MONTGOMERY COUNTY DEPARTMENT OF PARK AND PLANNING

January 9, 2002

The changes you propose for the main house – the gutters and storm doors - can be approved at staff level without applying to the Historic Preservation Commission for a HAWP. Since the HPC is meeting this evening, I will take this to their work session to confirm staff approval.

Address: 14800 Seneca Road, Darnestown	Meeting Date: 11/12/97
Resource: Master Plan Site #24/29, Magruder House	Review: HAWP
Case Number: 24/29-97B	Tax Credit: Partial
Public Notice: 10/29/97	Report Date: 10/05/97
Applicant: H. Richard Gault & Nancy J. Slomowitz	Staff: Perry Kephart
PROPOSAL: Fence Replacement, Barn Repair	RECOMMEND: Approval

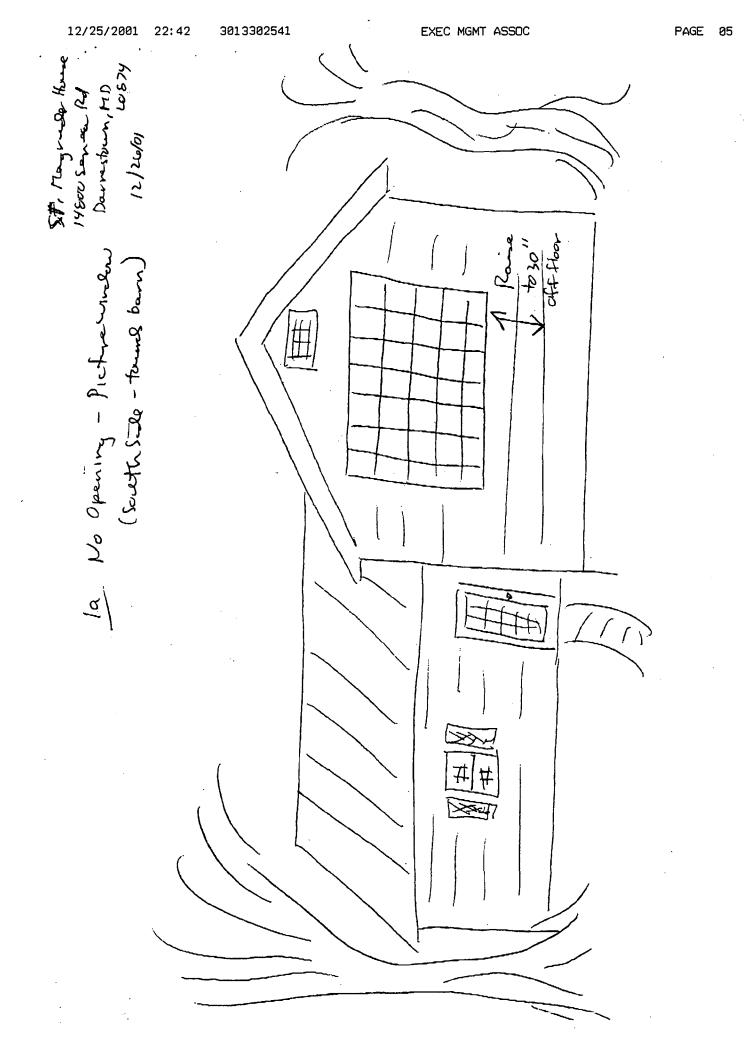
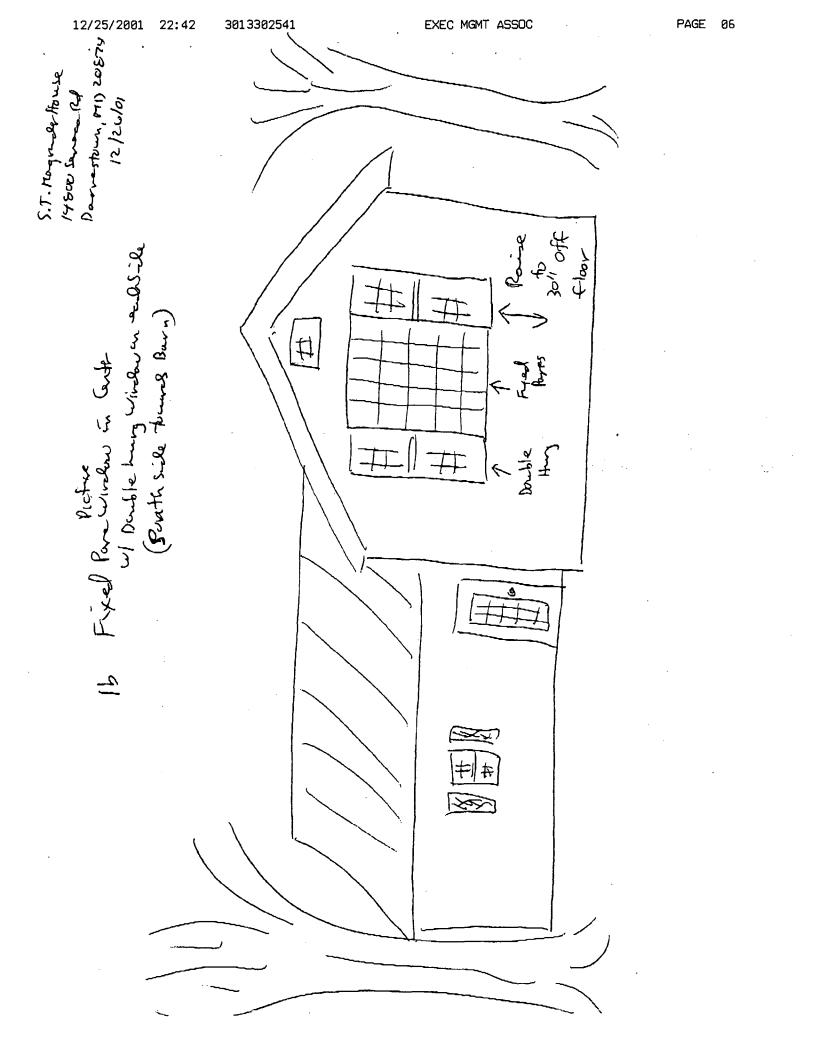
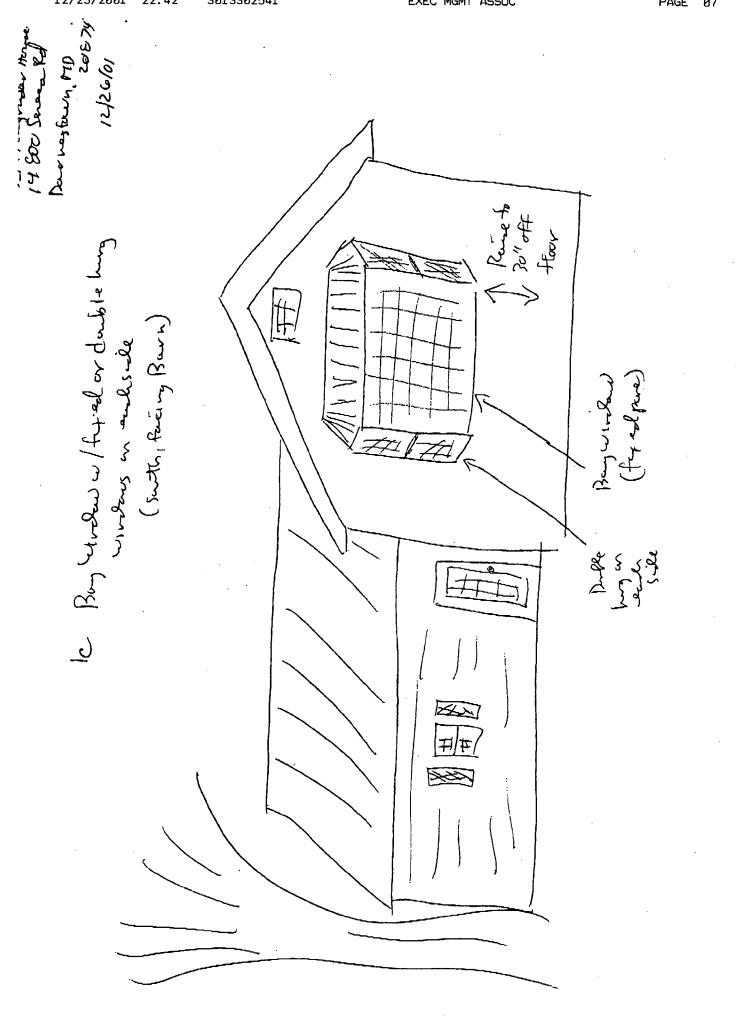
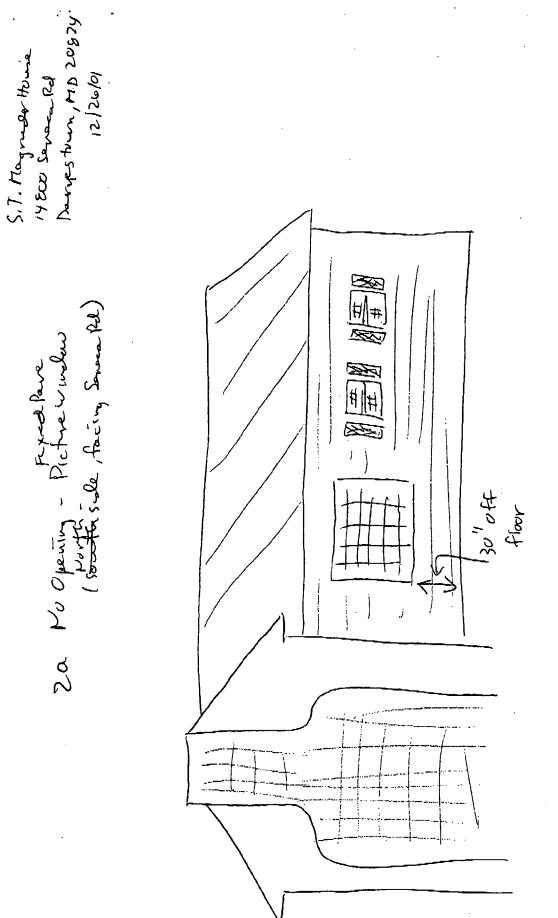
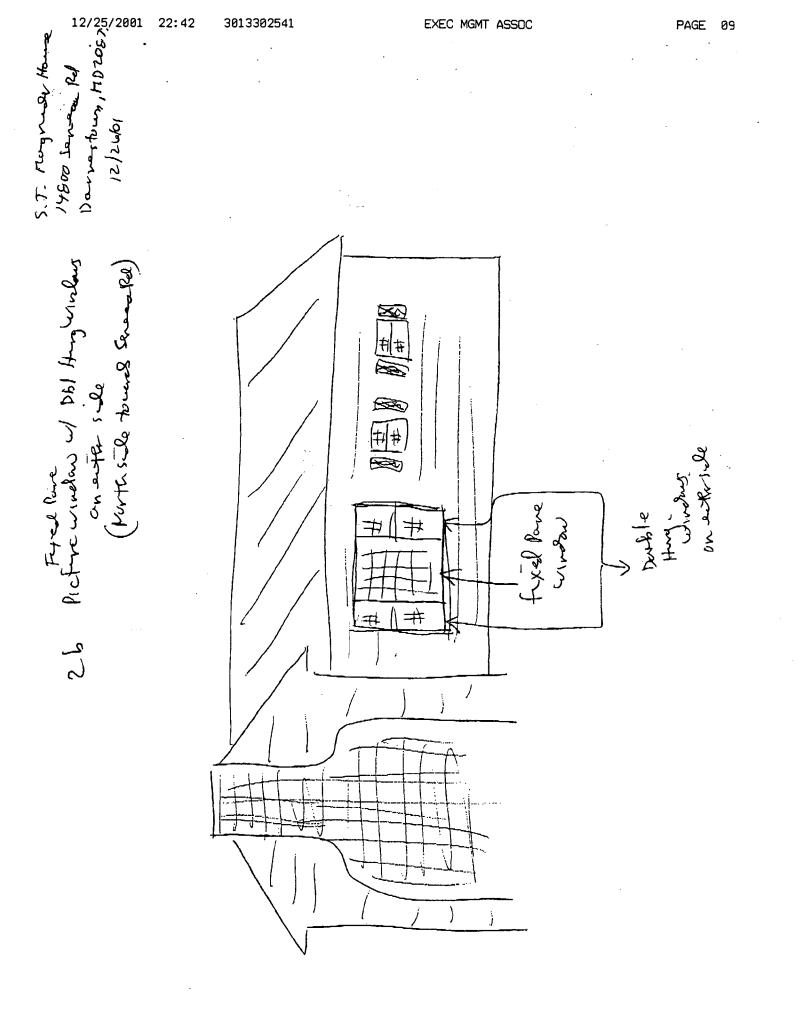
As to the window changes on the out-of-period tenant house, I would also approve those at staff level. The building is a non-contributing accessory structure, and you are not enlarging the building or otherwise changing the footprint. I would strongly recommend option 1-b with operable side windows, but without the bay in order to keep the changes to a minimum. Removal of the door can also be approved at staff level.
